**Re: Master Plan Amendment Request
Oso Wastewater Treatment Plant Collection System - Service Area 1
Service Boundary Area 1 – Wooldridge East Lift Station**

**WASTEWATER MASTERPLAN
 PROPOSED AMENDMENT EXHIBIT**

Exhibit A

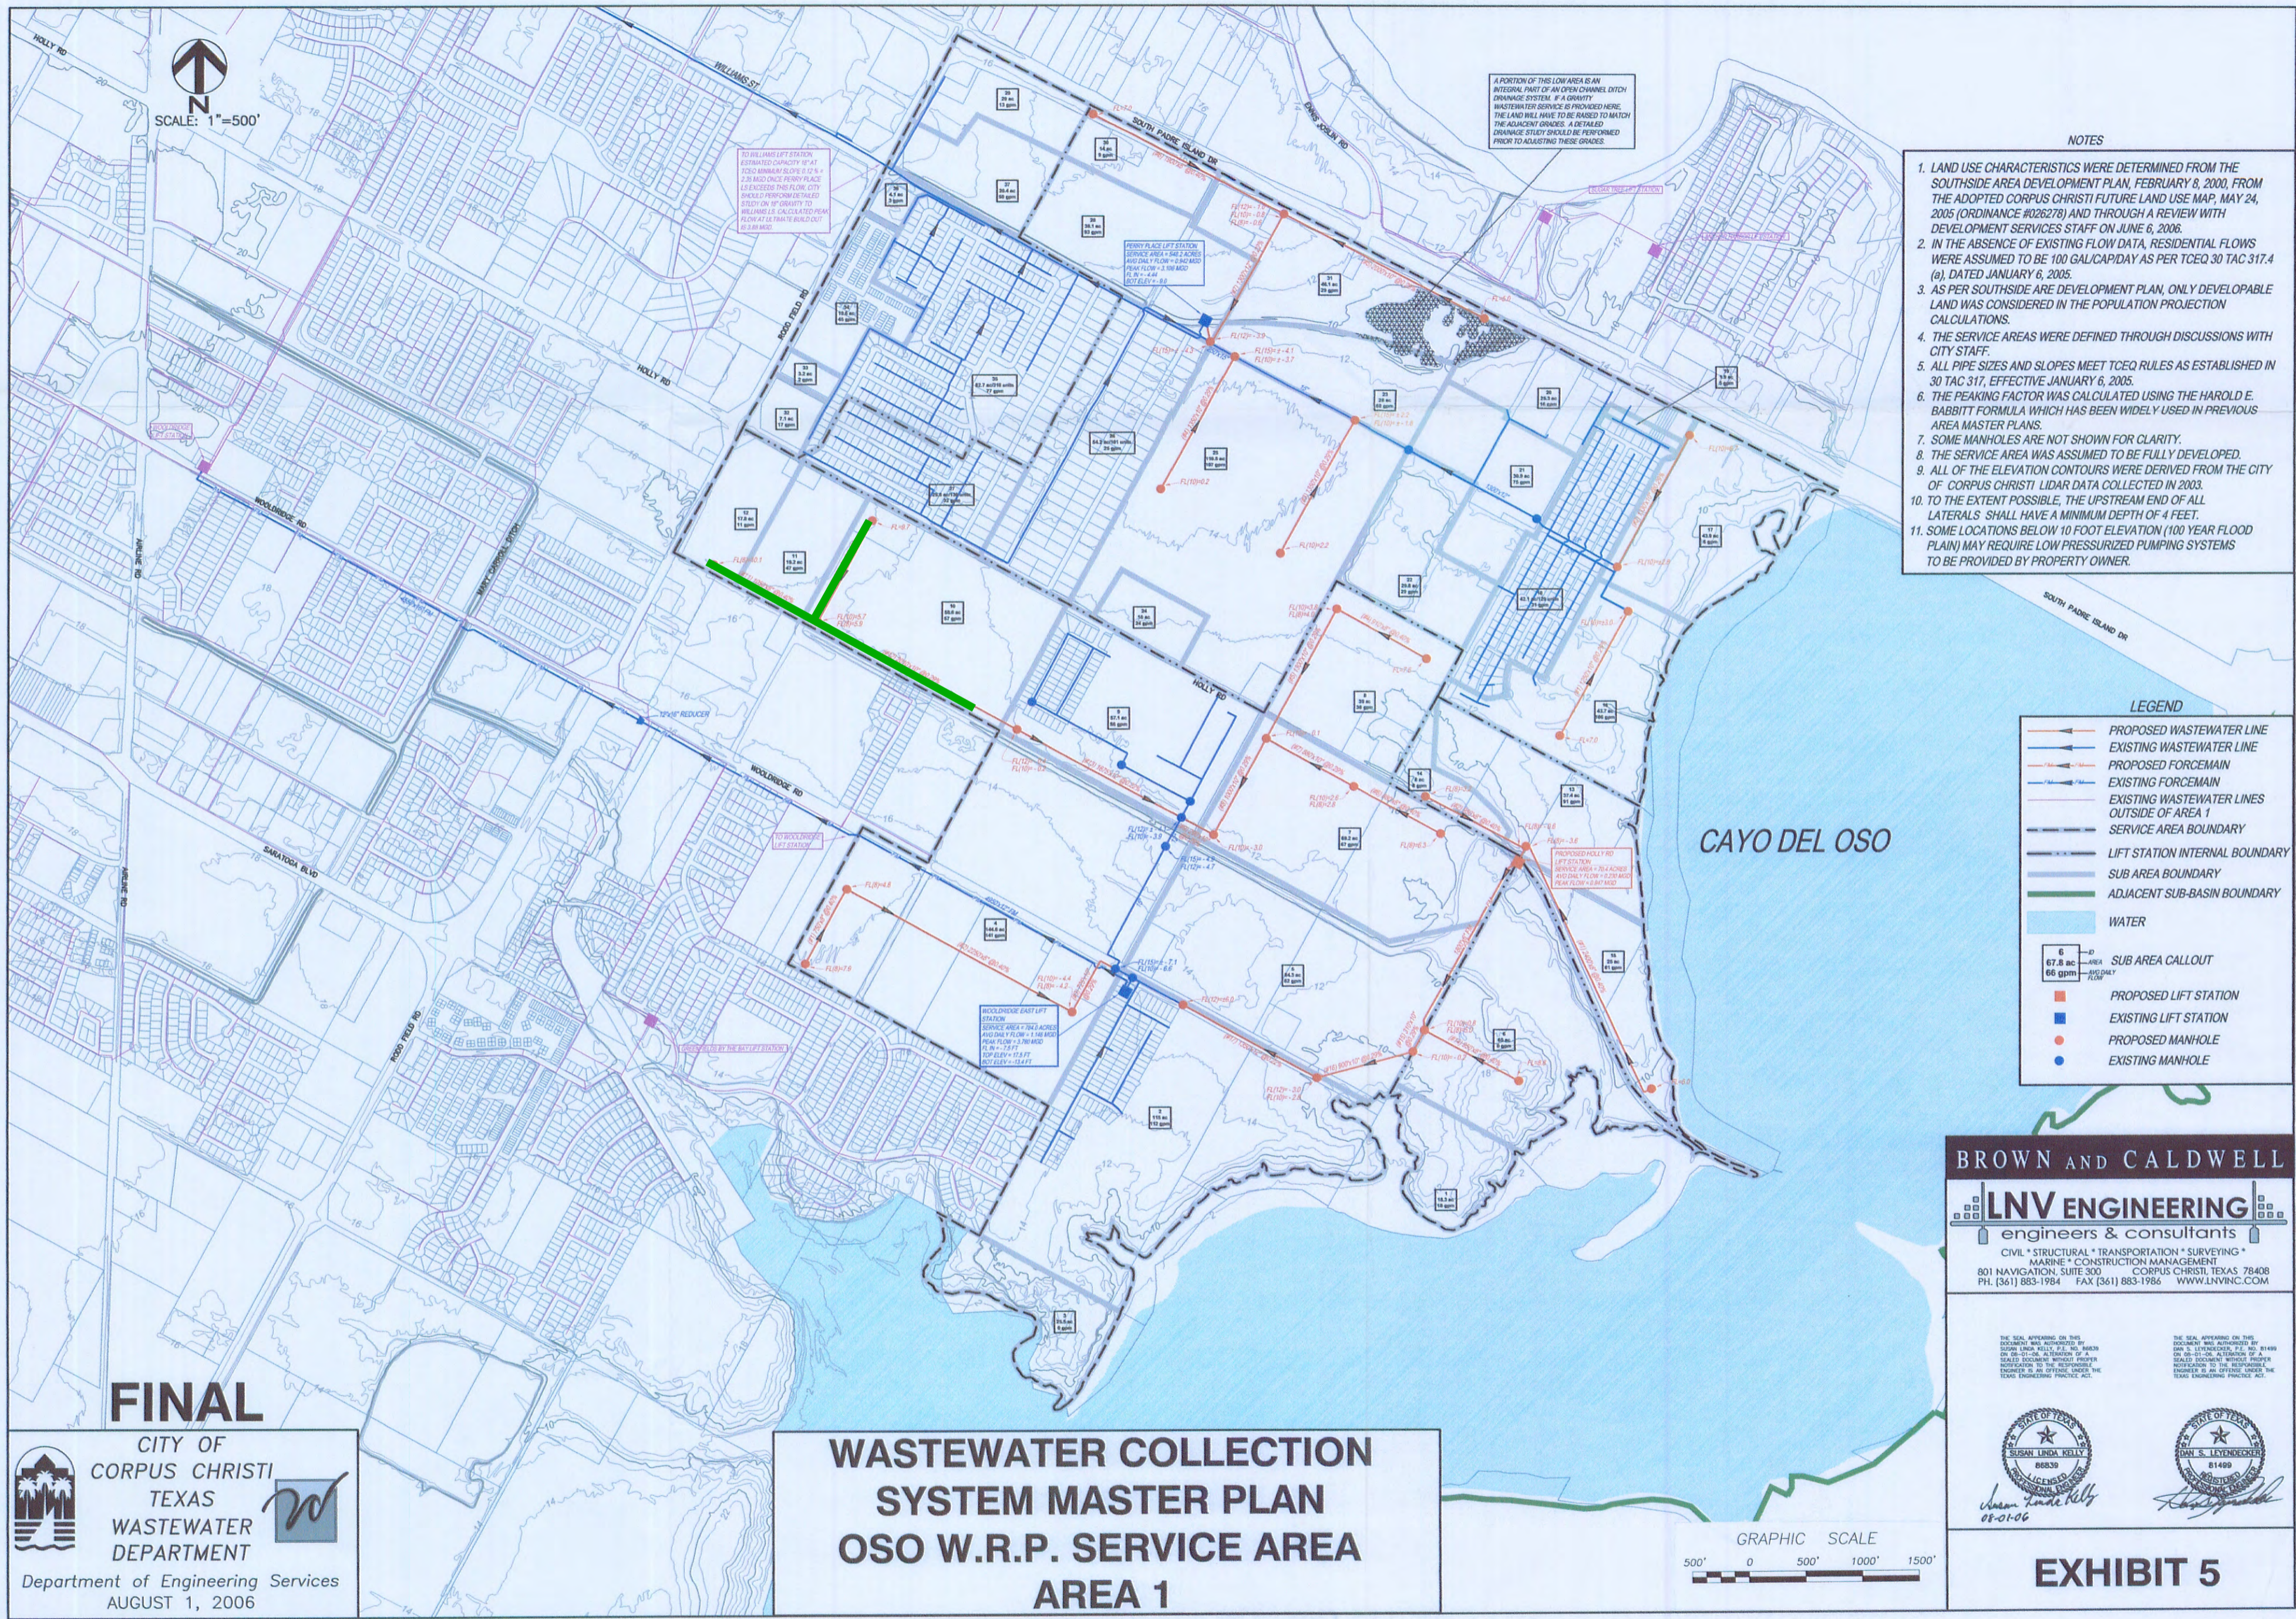
The approved Master Plan shows a service line to continue along the northern edge of the Drainage Easement for the Wooldridge Place Tributary from the southeastern corner of PLI's land. The collection line is shown as approximately 2,000 LF of 10" PVC and 1,050 LF of 8" PVC terminating approximately 200 ft. east of Rodd Field Road along the southern edge of the service boundary.

PRELIMINARY PLAT OF SANDY CREEK
 CITY OF CORPUS CHRISTI, NUECES COUNTY, TEXAS
 OCT 9 2018

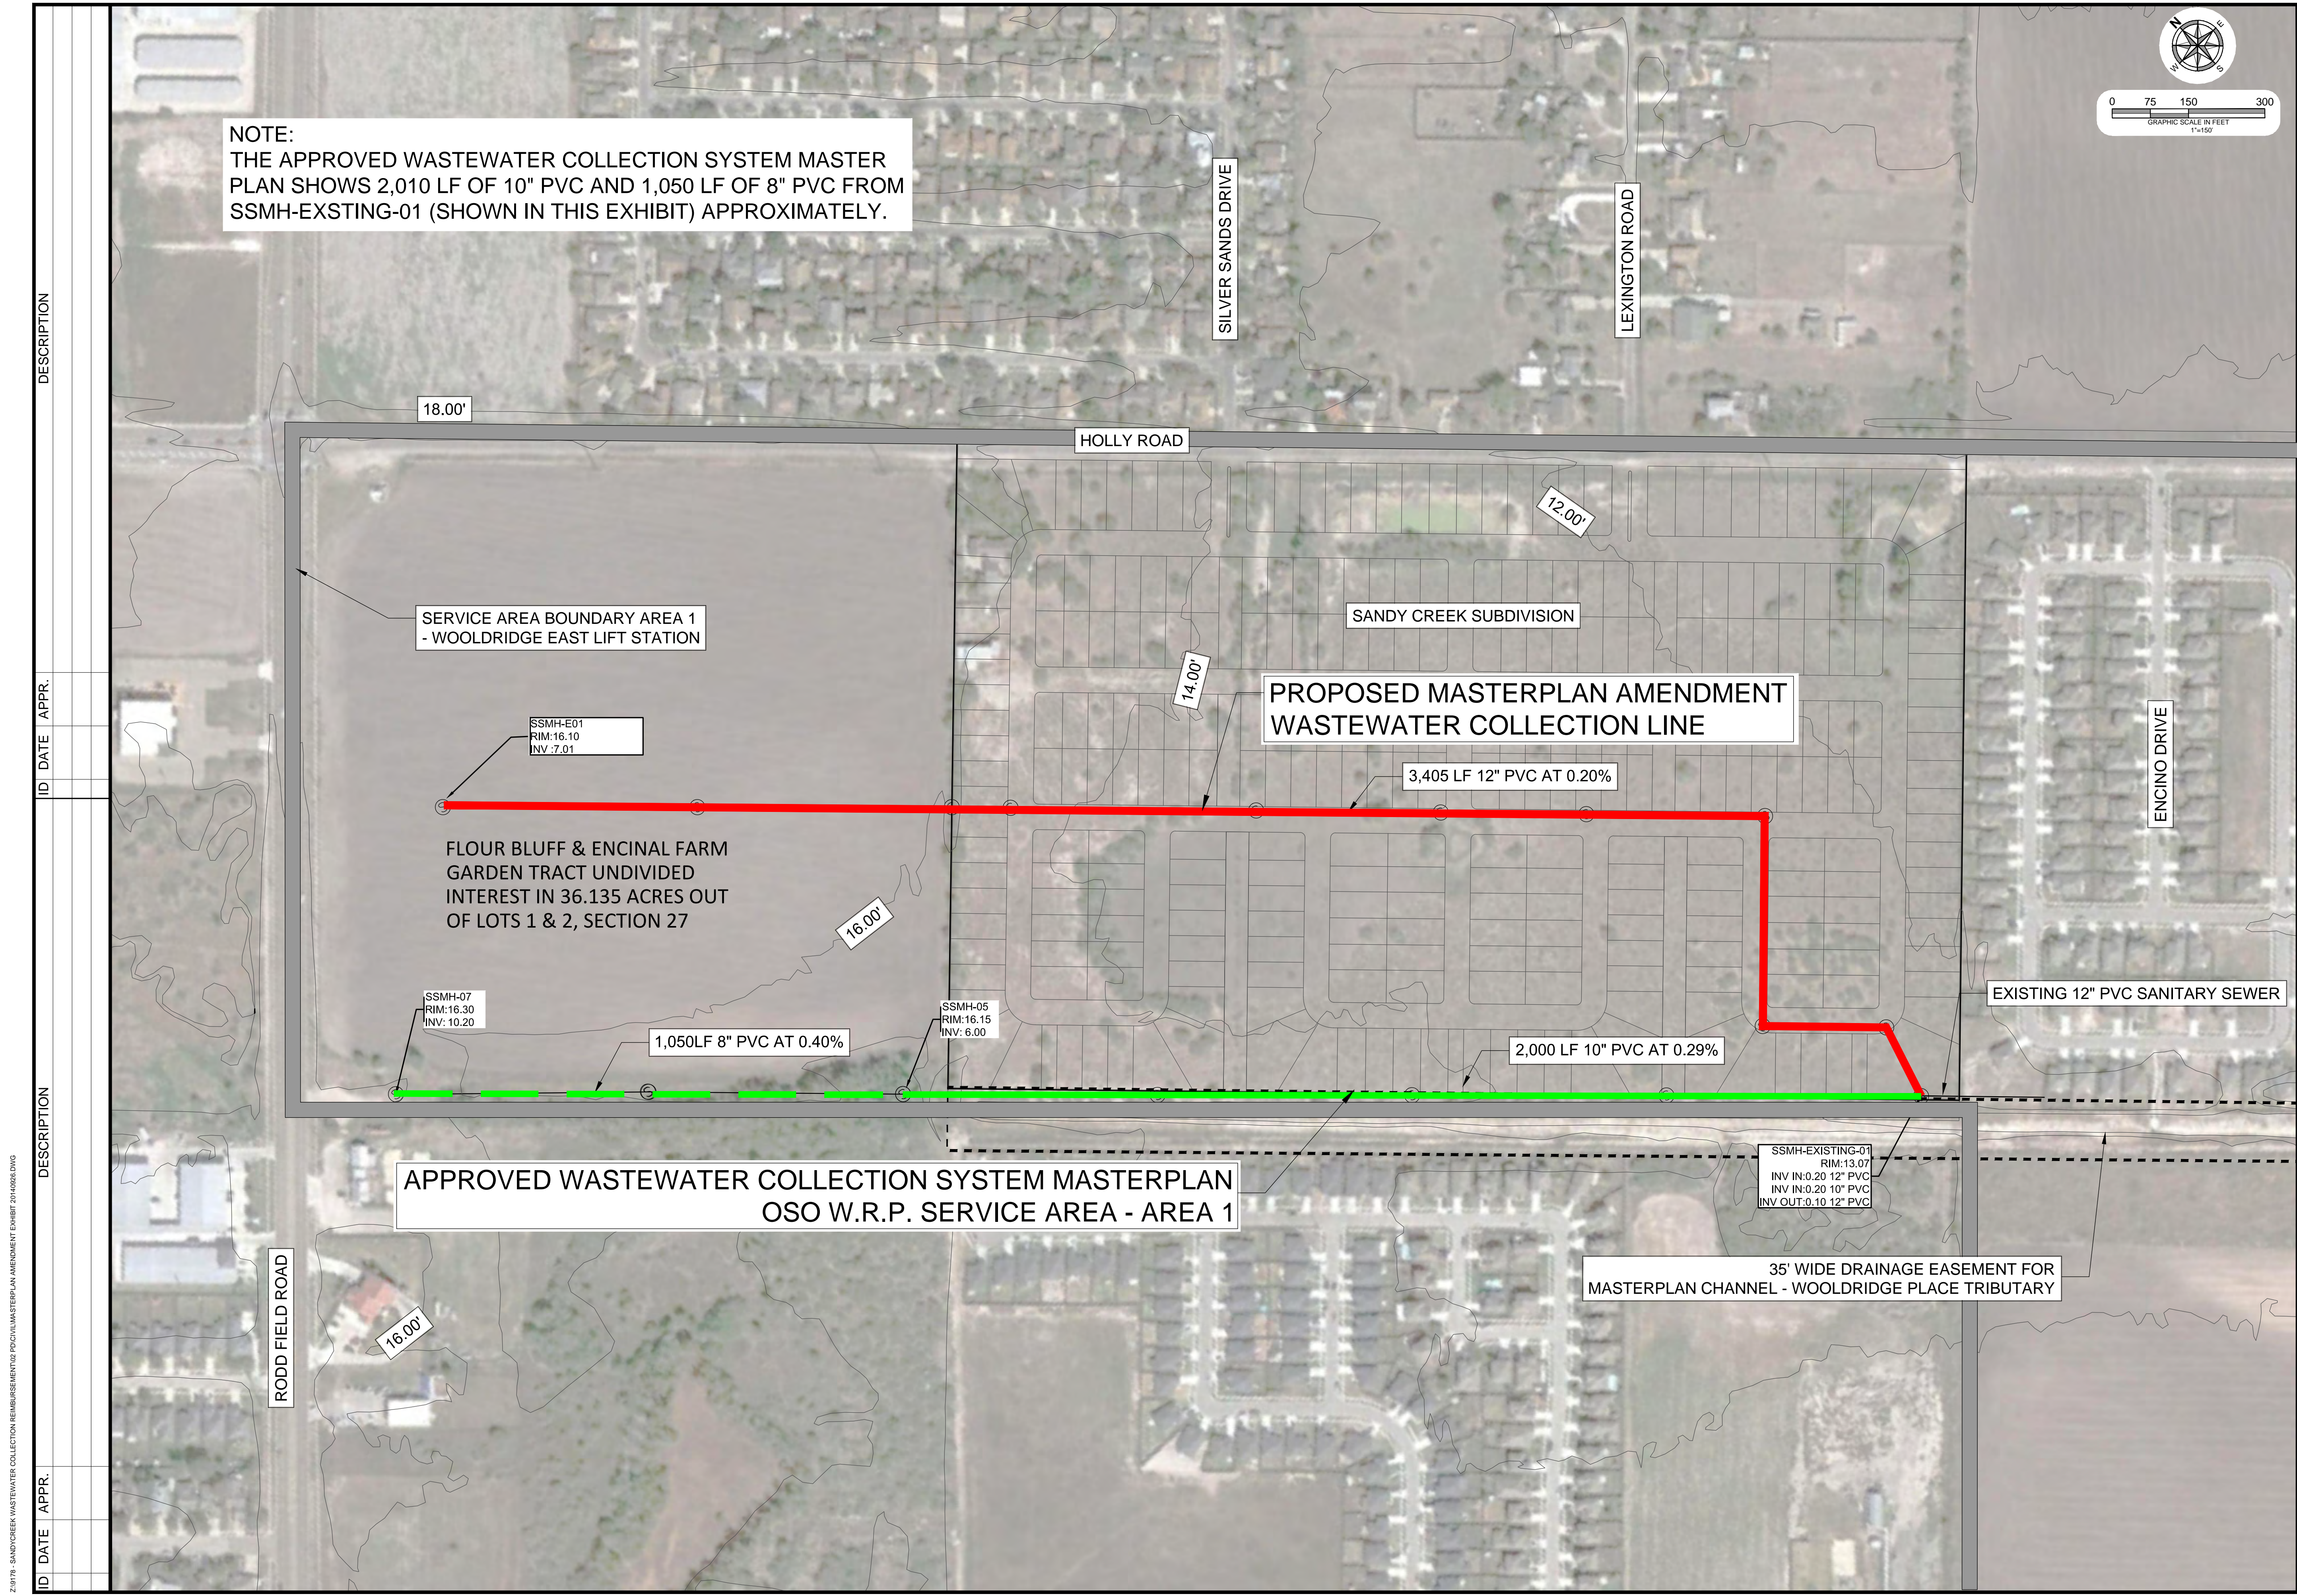
PLI has an approved preliminary plat for Sandy Creek Subdivision with a street layout as shown on *Exhibit B*. PLI is proposing to route the collection line within the planned public street right-of-ways as shown on *Exhibit C*. PLI feels that since a wastewater line would be needed in this location that a master planned collection within the drainage easement would only be a duplication of lines and would reduce the overall maintenance requirement of this line. This alignment would also place the collection line in the middle of its remaining service boundary (north and south).

Exhibit C

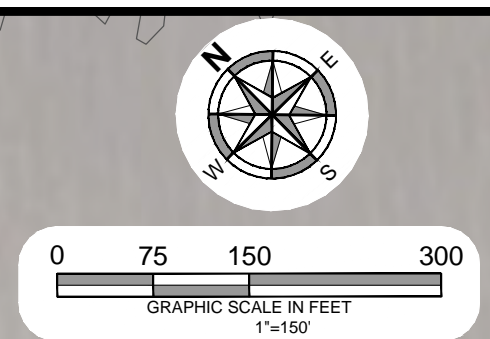
In addition, the City may want to consider using a larger diameter line, possibly continuing the 12" PVC line, to increase the depth and insure all areas within the service boundary to tie in.

NOTE:
 THE APPROVED WASTEWATER COLLECTION SYSTEM MASTER PLAN SHOWS 2,010 LF OF 10" PVC AND 1,050 LF OF 8" PVC FROM SSMH-EXSTING-01 (SHOWN IN THIS EXHIBIT) APPROXIMATELY.
